# Groundwater Transfer Review Summary Form

Transfer/PA # T- 14718

Application: T-14718

Applicant Name: Rockwood Water People’s Utility District and City of Gresham

Site Figure

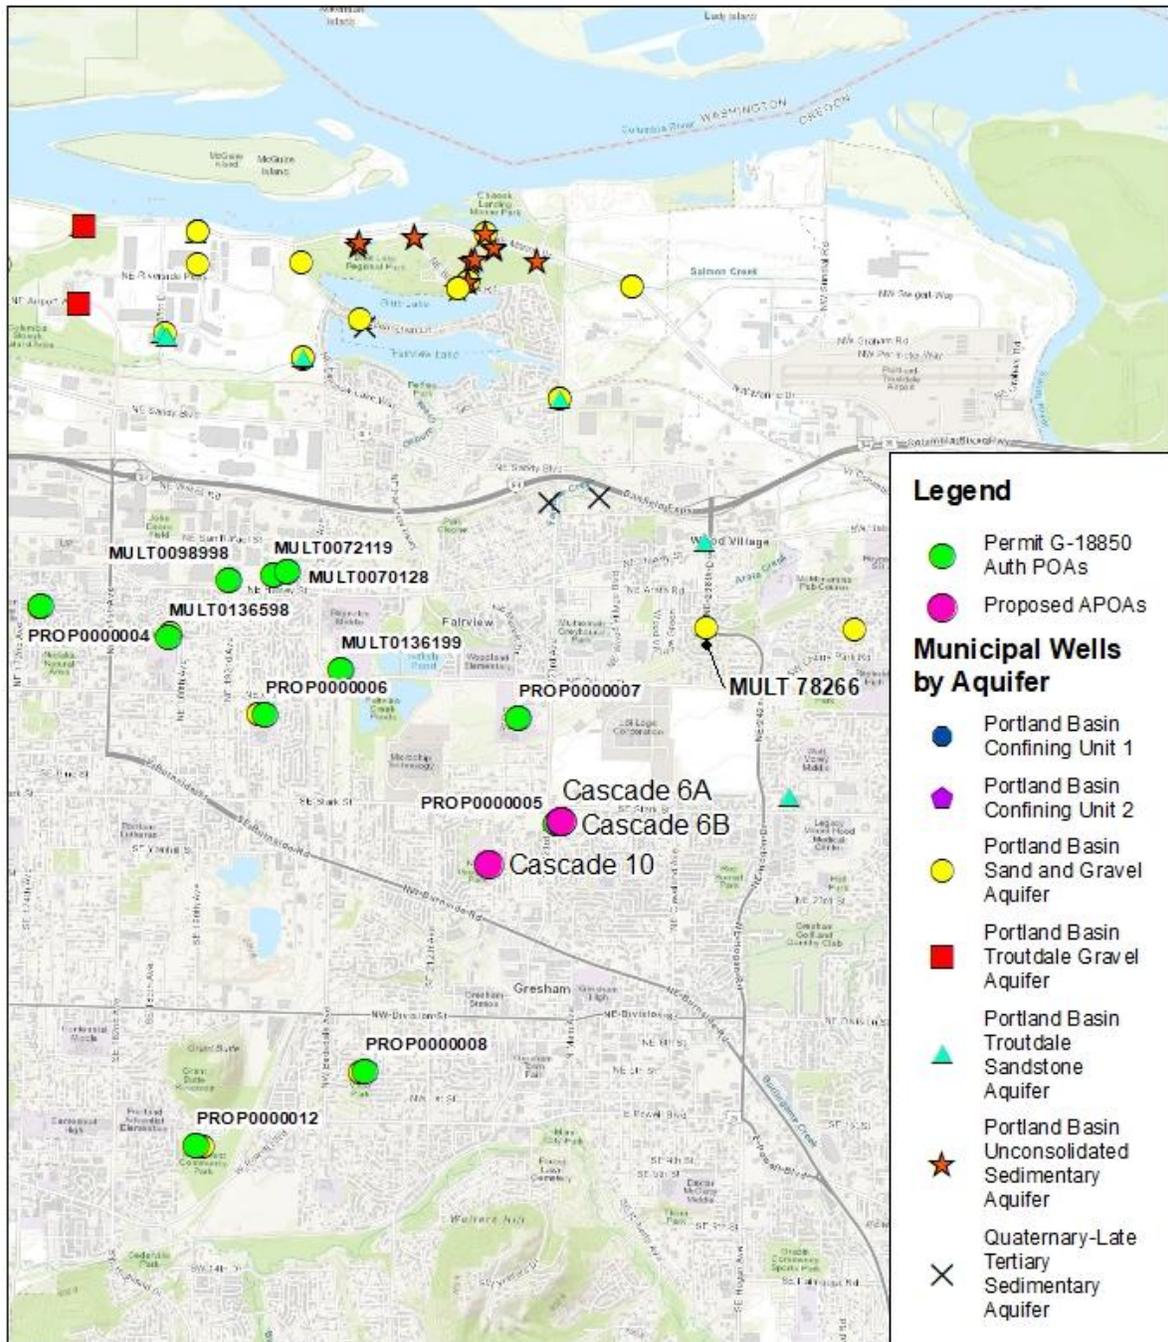
The proposed location of authorized POA 5 / Well 5 is approximately 1 mile from the mapped location of MULT 78266; in comparison, the proposed location of the APOAs (Cascade 6A, Cascade 6B, and Cascade 10) would be approximately 1.1 mile from the location of MULT 78266. Since proposed POA 5 / Well 5 is not yet drilled, potential for injury with MULT 78266 by pumping from Cascade 6B / MULT 122597 was evaluated as a protective measure. Relative to MULT 78266, the intervening distance of the proposed APOAs is greater than the distance between the authorized POA 5, such that it is unlikely that the proposed APOAs would increase interference with MULT 78266. However, since POA 5 / Well 5 is not yet drilled, potential interference with MULT 78266 was evaluated for this review by estimating the simulated pumping effects from proposed APOA MULT 122597 / Cascade 6B.

Modeled drawdown at MULT 78266 as a result of pumping at proposed APOA MULT 122597 / Cascade 6B (proposed scenario)

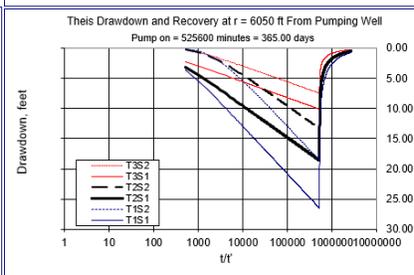
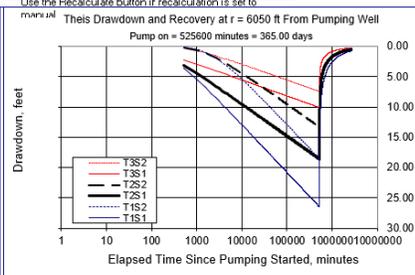
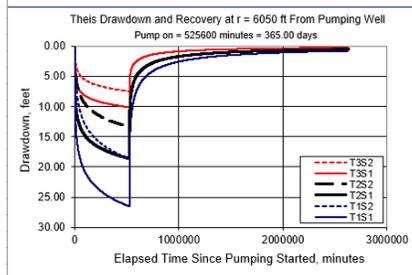
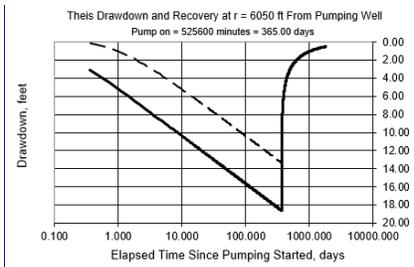
Yes  No If yes, explain: Well MULT 78266 was identified as the nearest well in the SGA that could experience the interference from the proposed APOAs. The additional interference was modeled using the Theis drawdown model (Theis, 1935) and a range of hydrogeologic parameter values derived from studies and pumping tests performed on the authorized and proposed POAs. The pumping rate was conservatively modeled at 5 cfs, based on the highest reported pumping rate of the authorized POAs (authorized POA 11/ MULT 136598 / Cascade 9). The aquifer thickness is based on the open interval in proposed APOA MULT 122597 / Cascade 6B.

The attached figures show that the maximum acute interference to MULT 78266 by pumping MULT 122597 would be approximately 6 to 26 feet, as compared to approximately 7 to 28 feet of acute interference by pumping from authorized POA 5 / Well 5.

Based on the modeled drawdown, estimated interference is below typical permit conditions and would not constitute substantial interference. Furthermore, the estimated interference would only constitute Substantial and Undue Interference (OAR 690-008-0001(8) (c)) if the well fully penetrated the SGA, which MULT 78266 does not. A fully-penetrating well at the location of MULT 78266 would access more than 1000 feet of saturated thickness, such that the estimated interference would not likely be sufficient to prevent another groundwater right from receiving the water to which it is legally entitled.
